**1999 Protégé with FMS Audio
Rear Speaker
[Recall 98011]**

SUBJECT: **Recall Campaign 98011**
1999 Protégé with FMS Audio – Rear Speaker

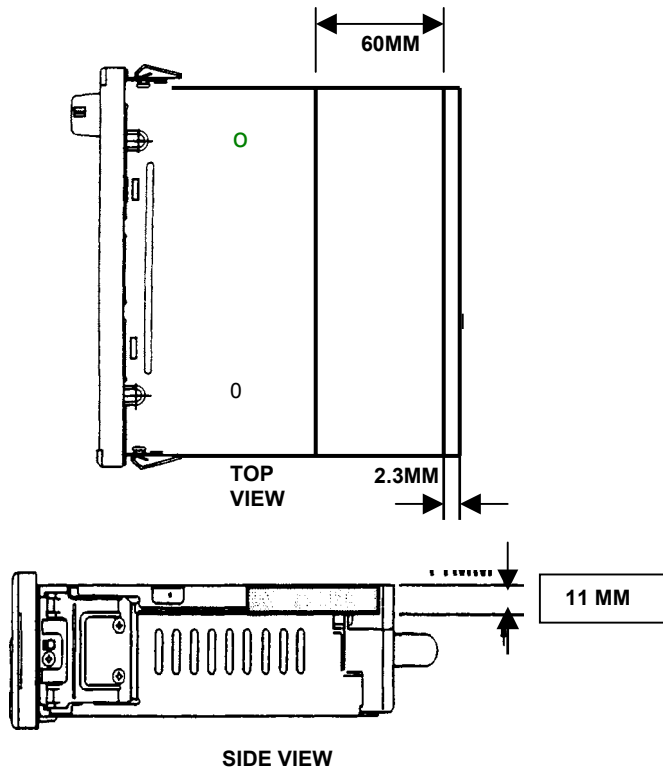
- Pull the SST (removal tool) outward and forward to slide out the audio unit.
- Disconnect the audio connector, antenna jack and remove audio unit.
- Place audio unit on a flat, clean work area and install protective tape using the dimensions shown in the following illustrations.

During installation of the tape, do not remove the entire piece of tape from its backing material. Instead, start one end of the tape and slowly apply it as you go along the top of the audio unit.
